Sundry ID: 2838103

Form 3160-5
(June 2019)UNITED STATES
DEPARTMENT OF THE INTERIOR
BUREAU OF LAND MANAGEMENTFORM APPROVED
OMB No. 1004-0137
Expires: October 31, 2021**SUNDRY NOTICES AND REPORTS ON WELLS**
Do not use this form for proposals to drill or to re-enter an abandoned well. Use Form 3160-3 (APD) for such proposals.5. Lease Serial No. **MULTIPLE**
6. If Indian, Allottee or Tribe Name
MULTIPLE**SUBMIT IN TRIPLICATE - Other instructions on page 2**

XTO respectfully requests approval to make the below listed changes to the approved APDs.

JRU Apache Federal Com 113H 30-015-55783

Previous Design: 4-String Design – Engineered Weak Point**[Figure F] 4 String – 2nd Intermediate casing engineered weak point**

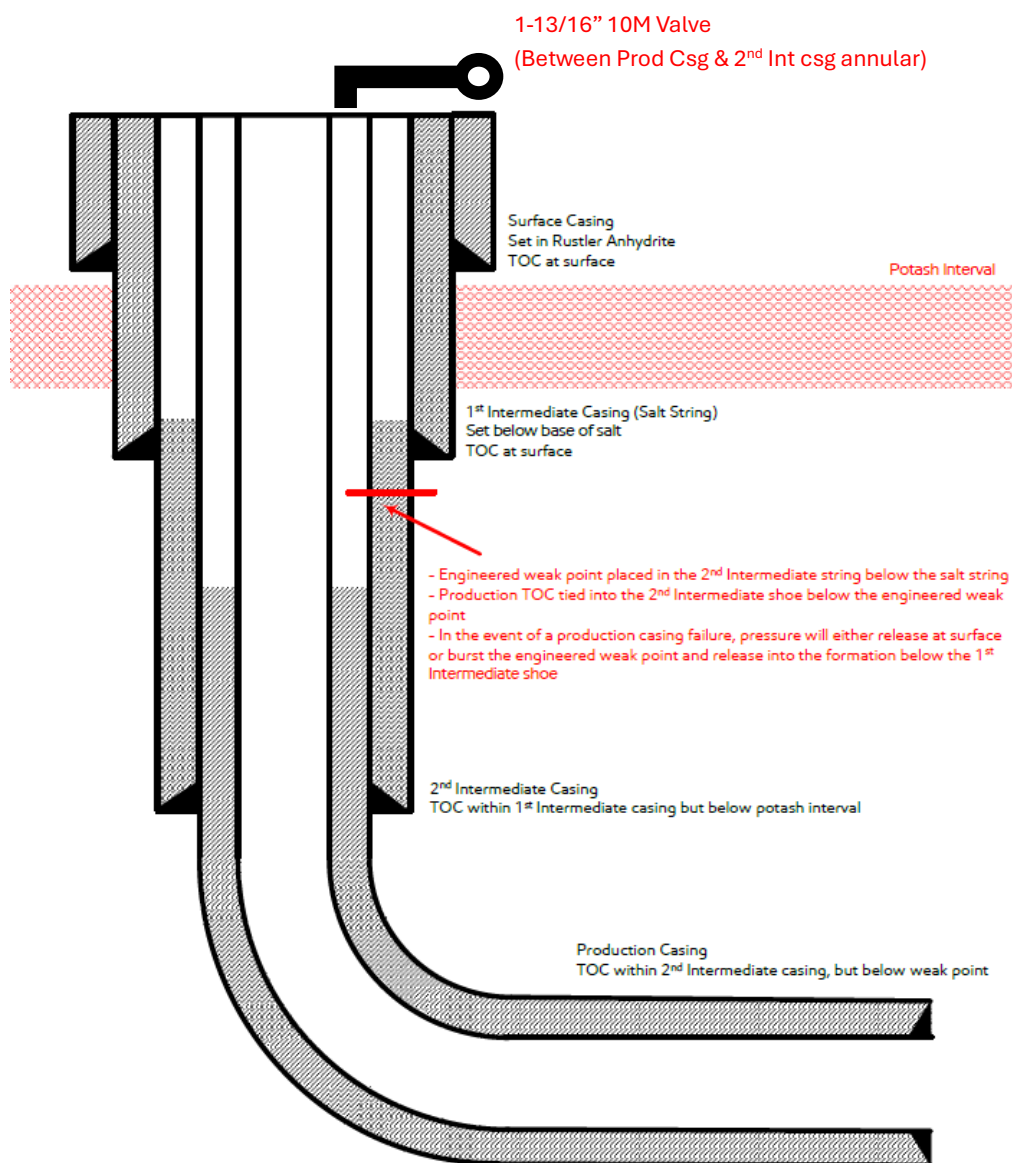
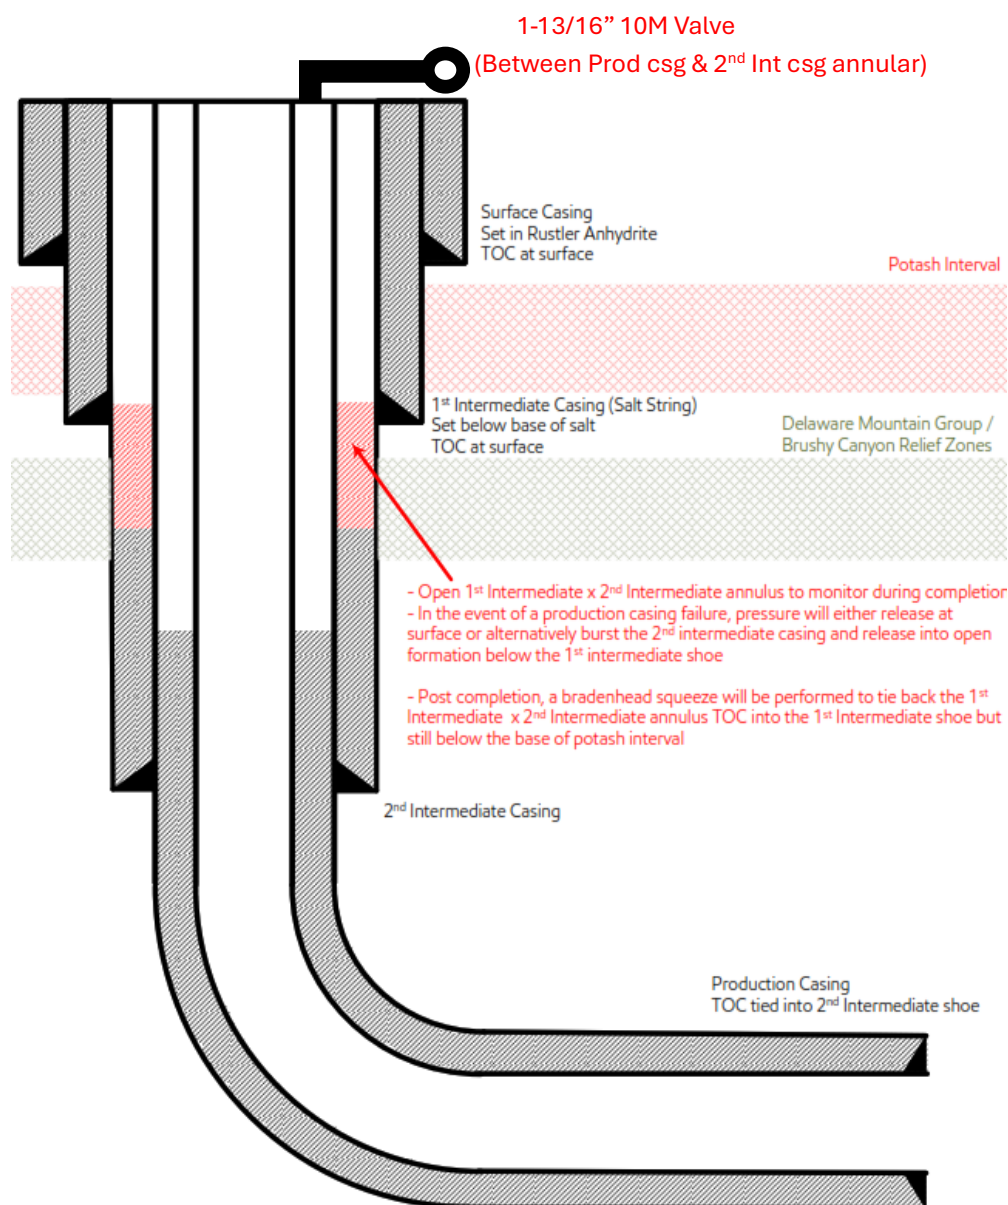
1. Casing design to be changed from the "4-String Design – Engineered Weak Point" (FIGURE F) to the "4-String Design – Open 1st INT x 2nd INT Annulus" (FIGURE D). An open annulus will be utilized and monitored during completions operations.

Post completion, bradenhead squeeze will be performed to tie back the 1st intermediate x 2nd intermediate annulus. TOC will be placed into the 1st intermediate shoe but still below the base of Potash interval.

2. No changes to the cementing, casing or mud circulating system designs will be required for the requested change.

- 1) Alignment with KPLA requirements per schematic per schematic below, with engineering weak point casing design and utilizing new casing that meets API standards.
- 2) Contingency plans in place to divert fluids away from salt interval in event of production casing failure.
- 3) Intermediate 2 casing will consist of a primary cement job with TOC at the top of the Brushy Canyon formation within the Delaware Mountain Group.
 - a. Bradenhead squeeze to be completed after primary cement job to tie back TOC to intermediate 1 "Salt string" at least 500' but with top below Marker Bed 126 "Potash Interval".
- 4) Production cement to be tied back no less than 500' inside previous casing shoe (intermediate 2 casing) and below the engineered weak point.

New Proposed Design: 4 – String Design – Open 1st Int X 2nd Int Annulus (ICP 2 below relief zone)

[Figure D] 4 String – Uncemented annulus between 1st and 2nd intermediate casing strings

- 1) Alignment with KPLA requirements per schematic above, leaving open annulus open for pressure monitoring during frac and utilizing new casing that meets API standards.
- 2) Contingency plans in place to divert fluids away from salt interval in event of production casing failure.
- 3) Intermediate 2 bradenhead squeeze to be completed within 180 days to tieback TOC to salt string at least 500ft but with top below Marker Bed 126.
- 4) Production cement to be tied back no less than 500ft inside previous casing shoe.
